Transportation Impact Study Addendum

PROPOSED RESIDENTIAL DEVELOPMENT

Harvest Moon Drive and Emil Kolb Parkway
Town of Caledon

**Re: Engineering Service – Transportation Impact Study Addendum
Proposed Residential Development
Harvest Moon Drive and Emil Kolb Parkway, Town of Caledon
Our Project No. NT-20-113**

Figure 2-1 – Inbound Trip Distribution

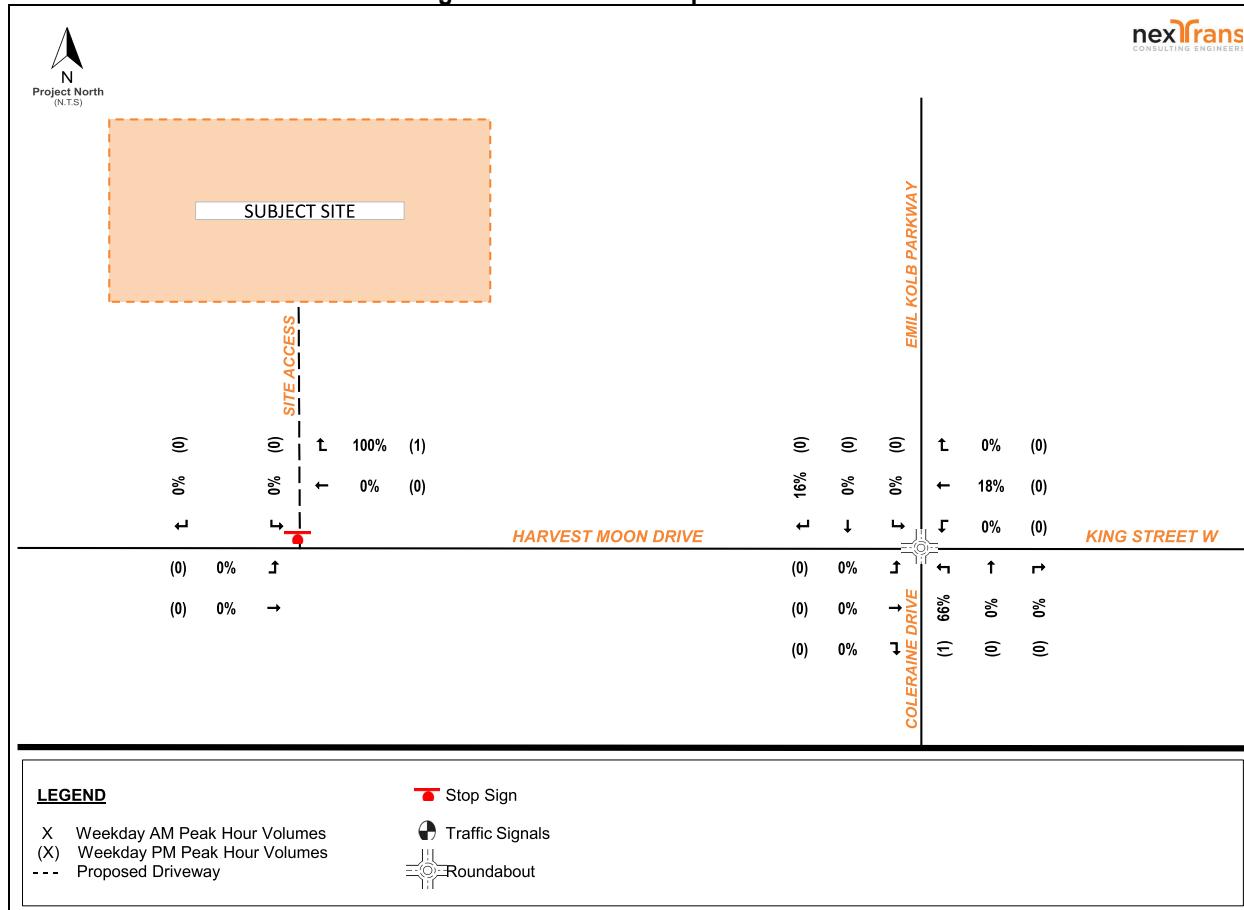
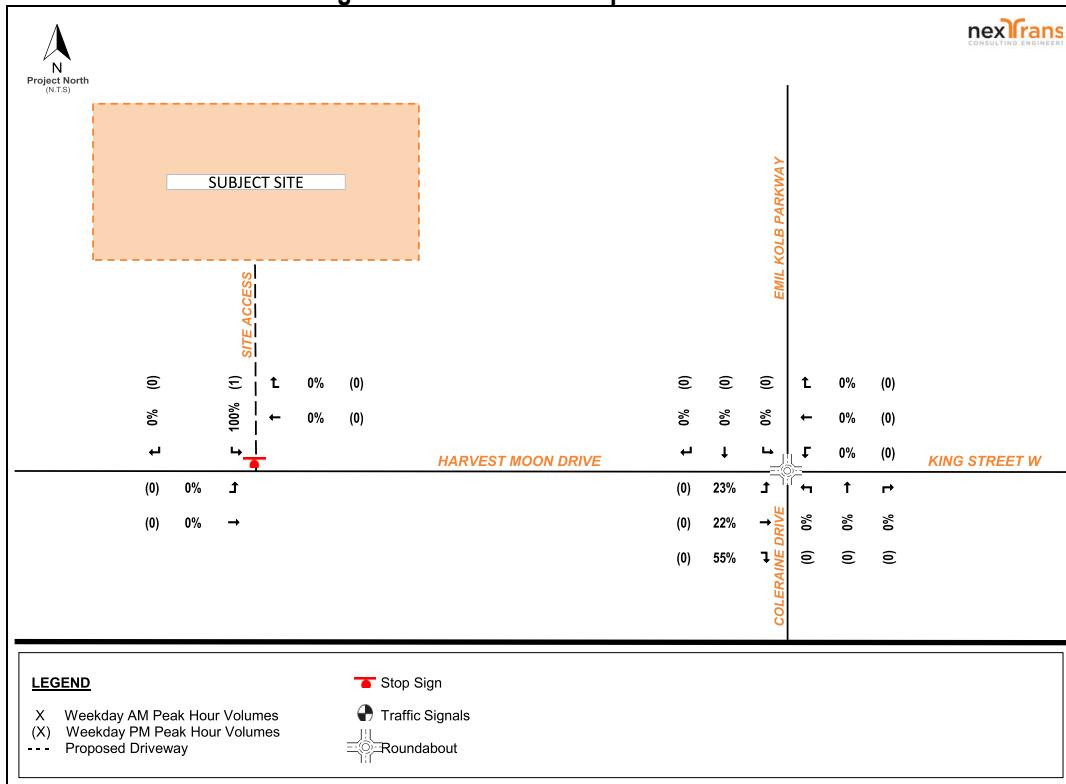
5. *Please provide a traffic distribution figure indicating the percentage of site-generated traffic assigned to each roadway segment in the study area.*

NEXTRANS RESPONSE: A traffic distribution figure with percentages is provided in this Addendum.

Figure 5-1

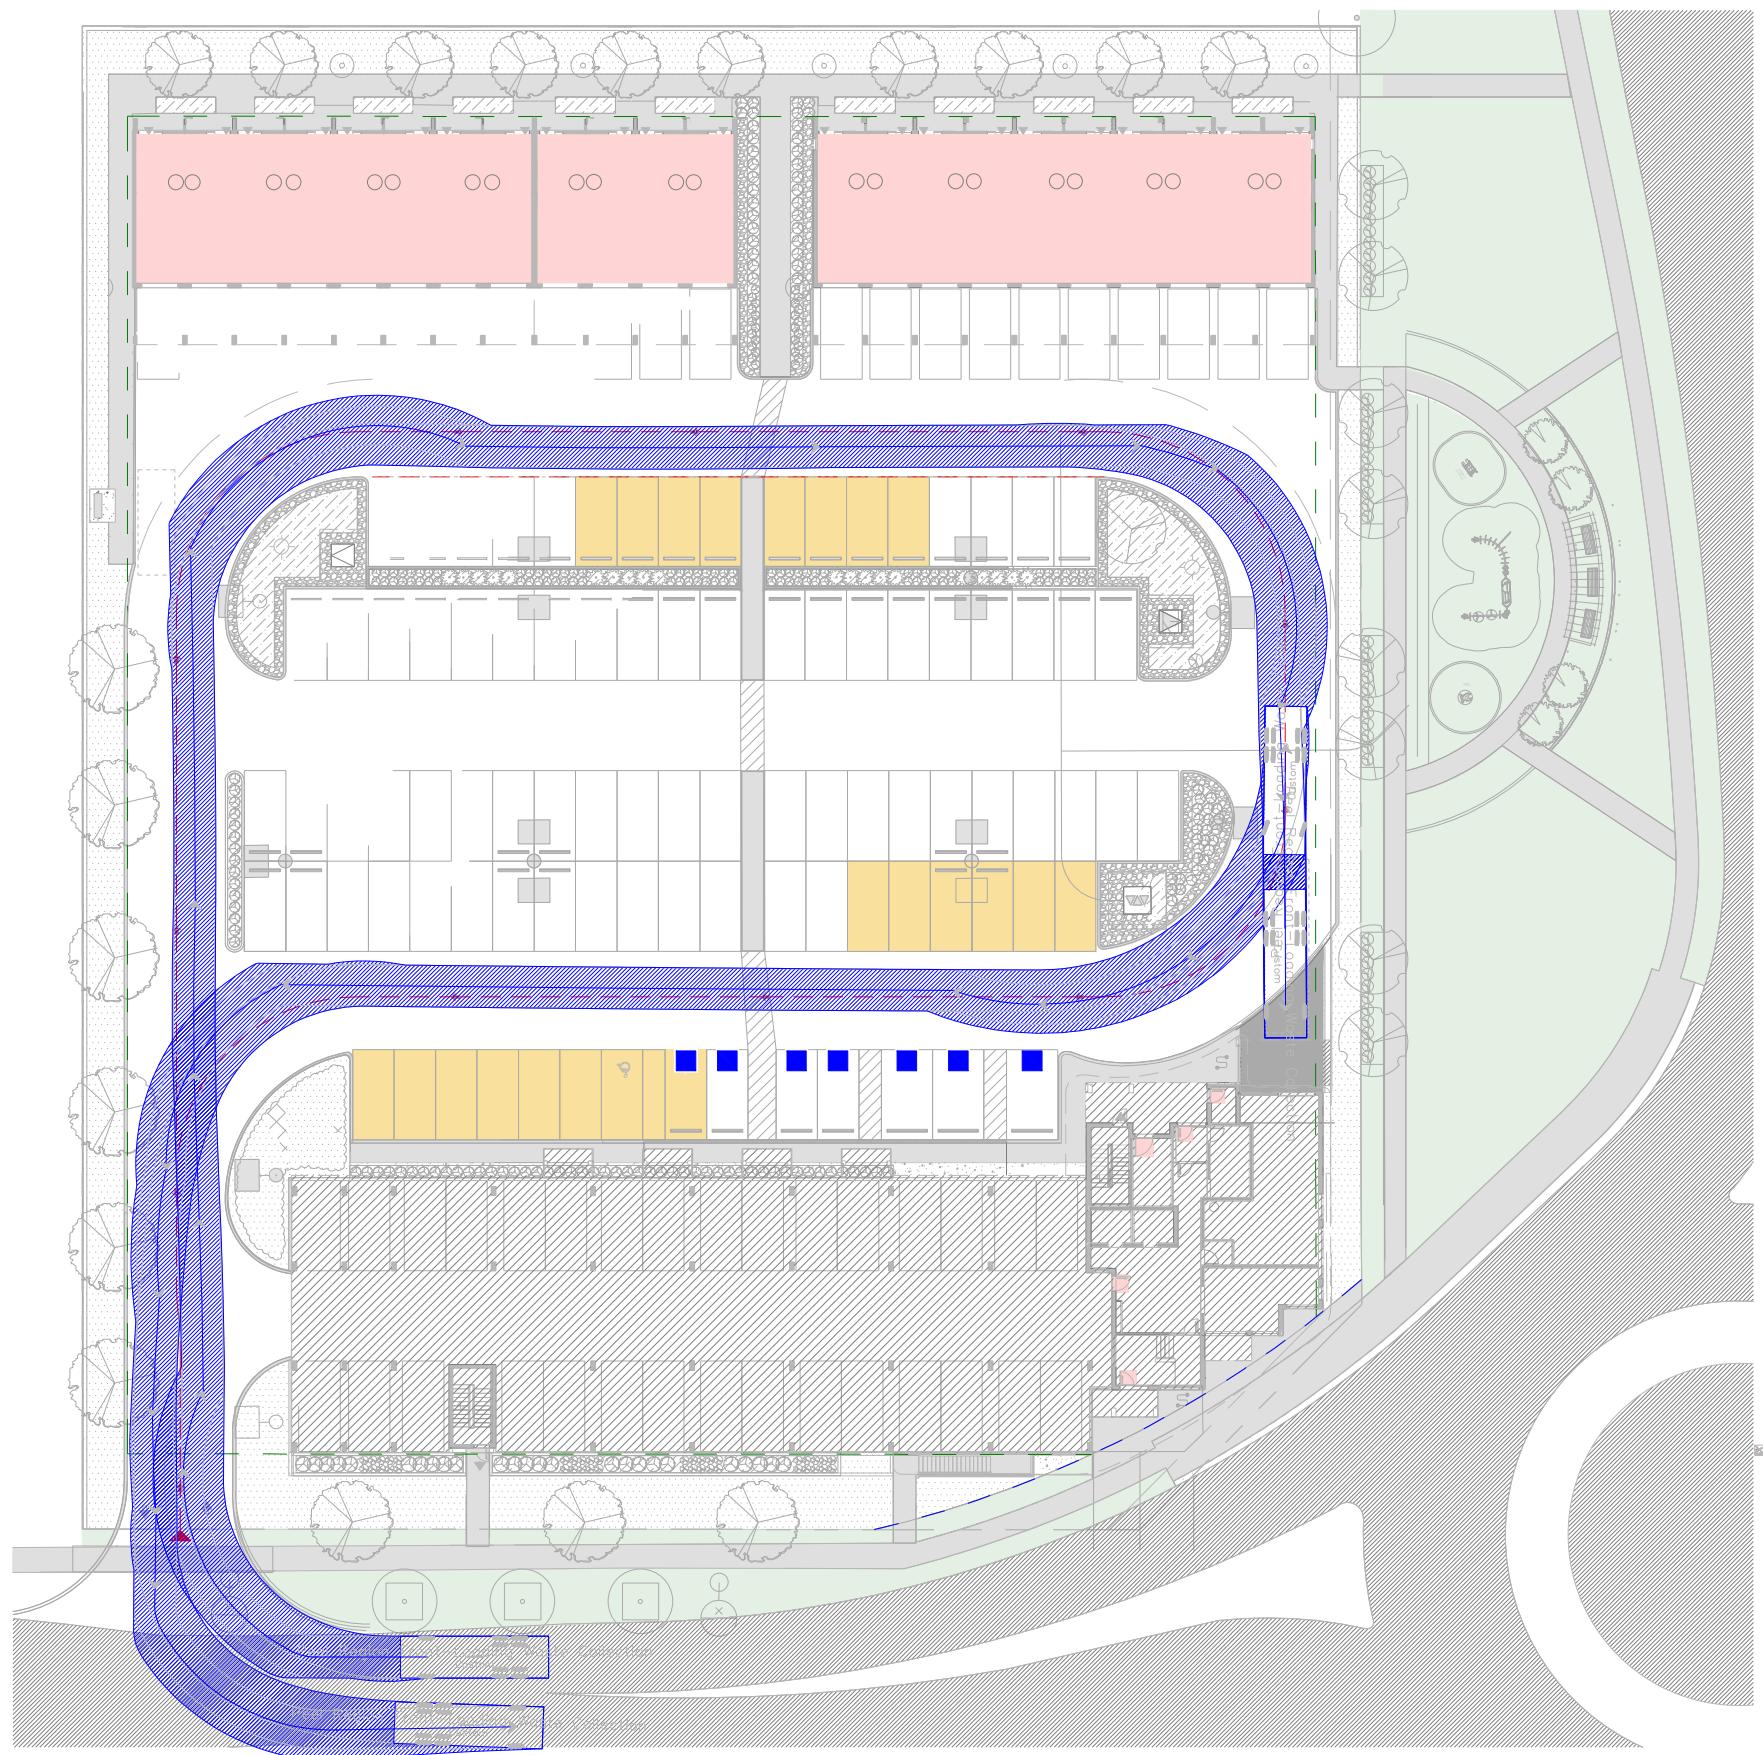
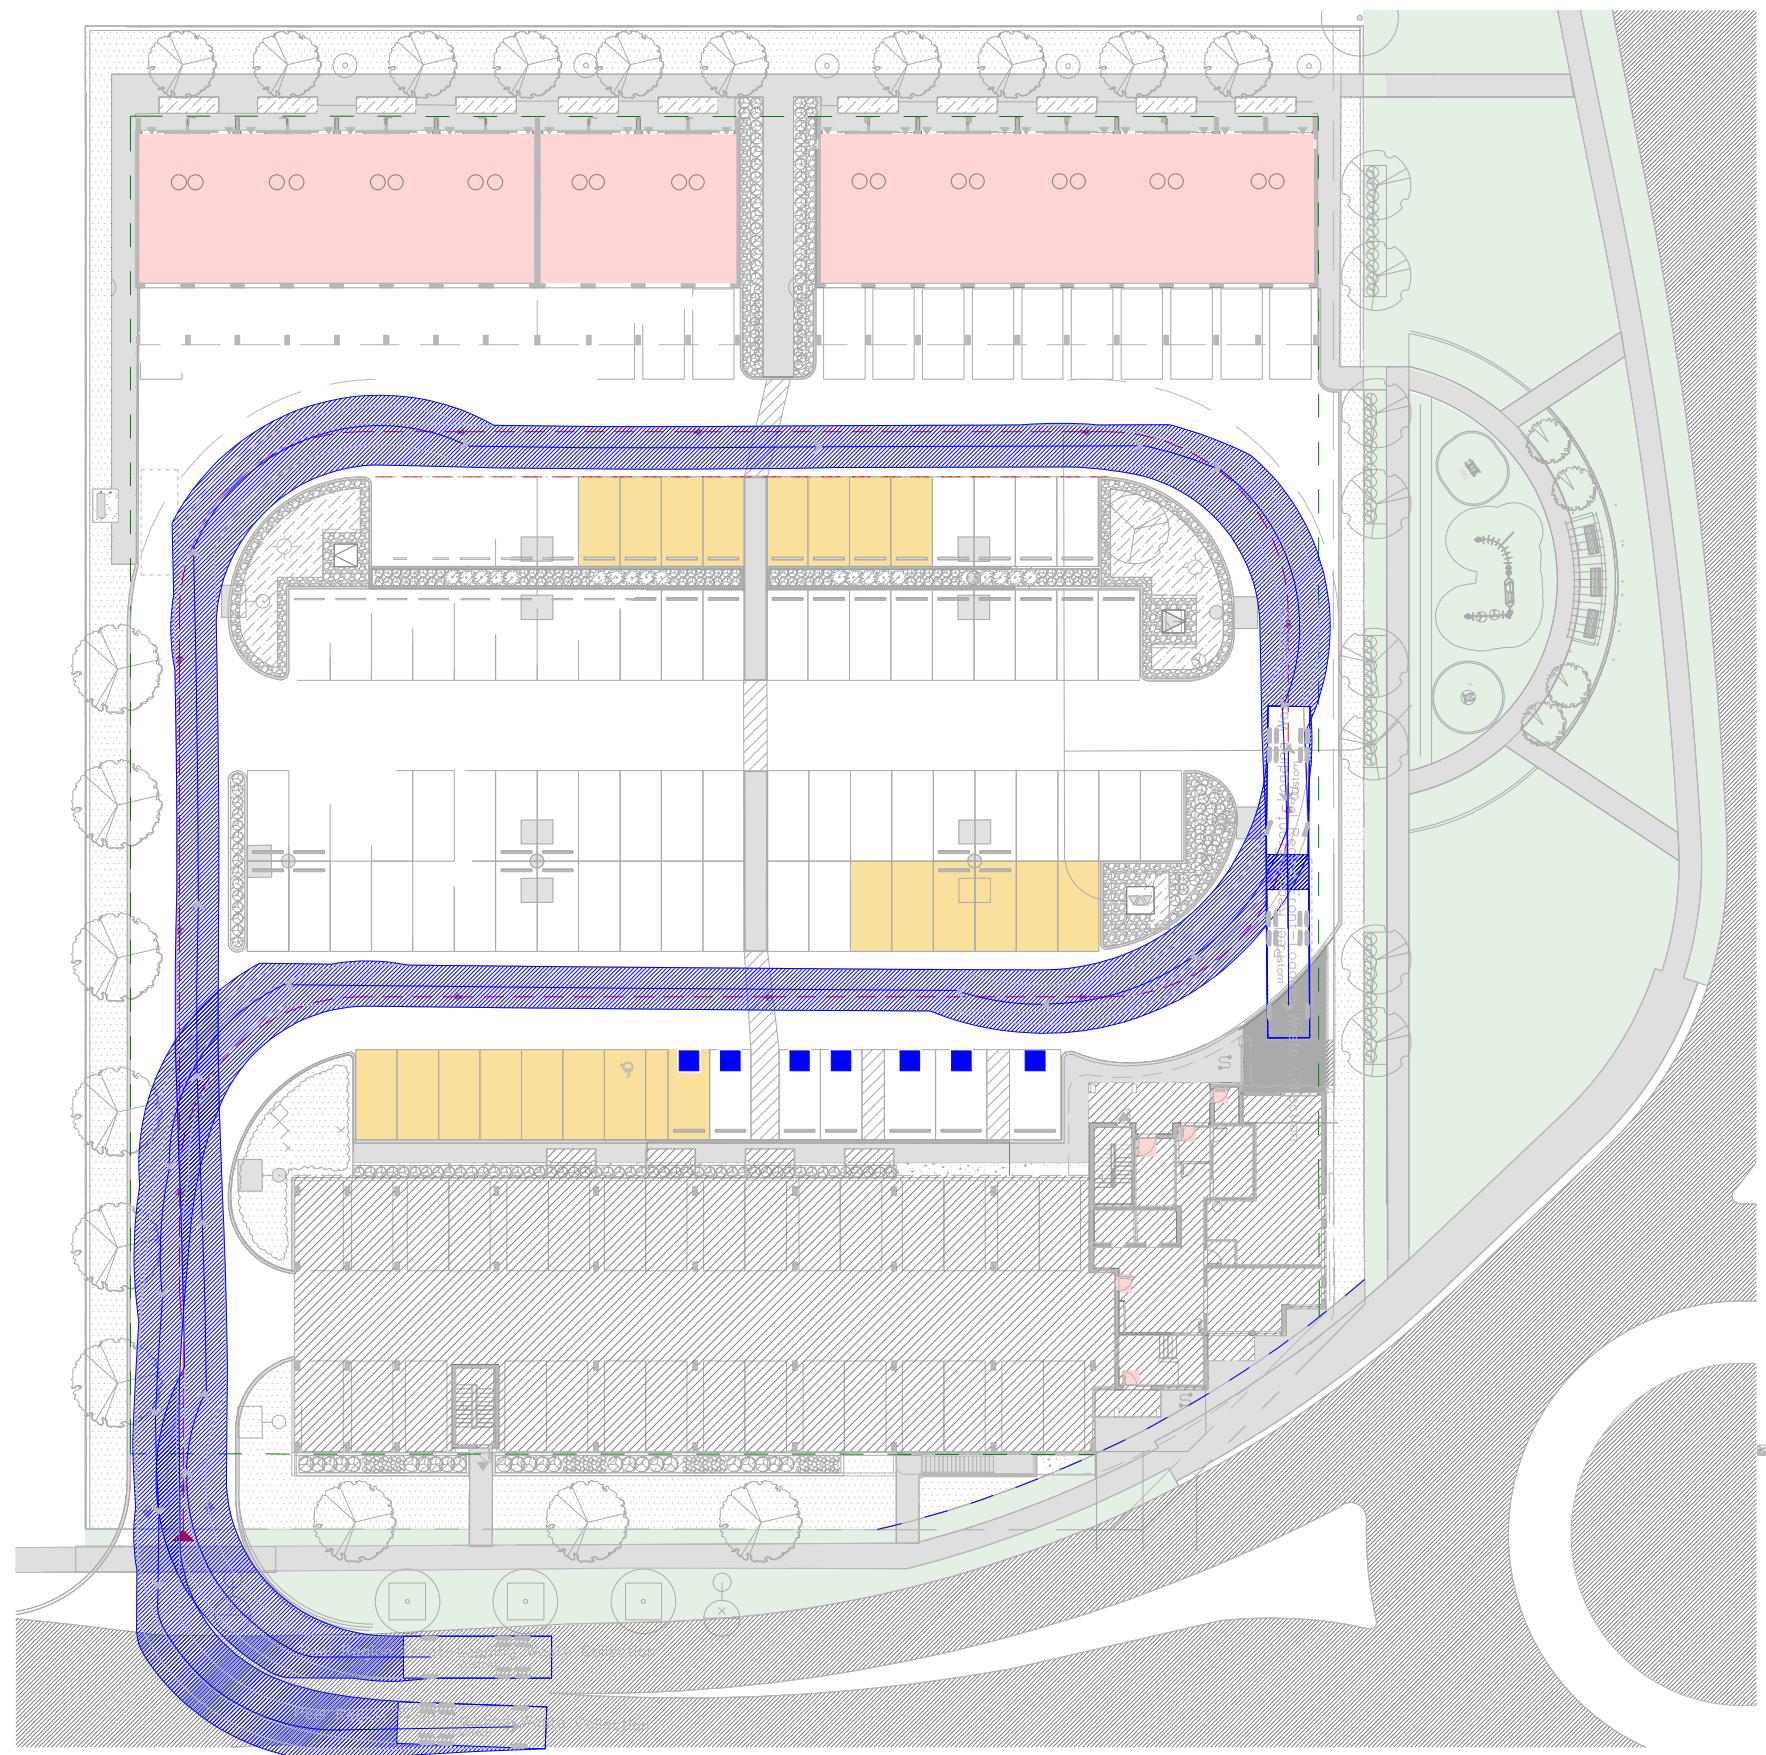
11. A detailed review of the access geometry related to OTM/TAC guidelines should be included. The review should include but not be limited to: sight distances; roadway curves (vertical and horizontal) standards; clear zones; conflicting vehicle movements within and adjacent to the development; and on-site vehicle swept path analysis (AutoTurn) utilizing the proper design vehicles (buses, fire trucks, garbage trucks, snowplows, etc., as v Plan review is provided in this Addendum.

AutoTURN software was used to generate a vehicular turning template to confirm and demonstrate the accessibility of the proposed study area. The AutoTURN analysis demonstrates that a Peel Region front-loading waste collection vehicle can access the loading space without conflict. Additionally, AutoTURN analysis demonstrates that an Aerial Fire Truck (NCHRP Report 659) can access the fire route. The AutoTURN analysis is provided in **Figure 5-1** and **Figure 5-2**.
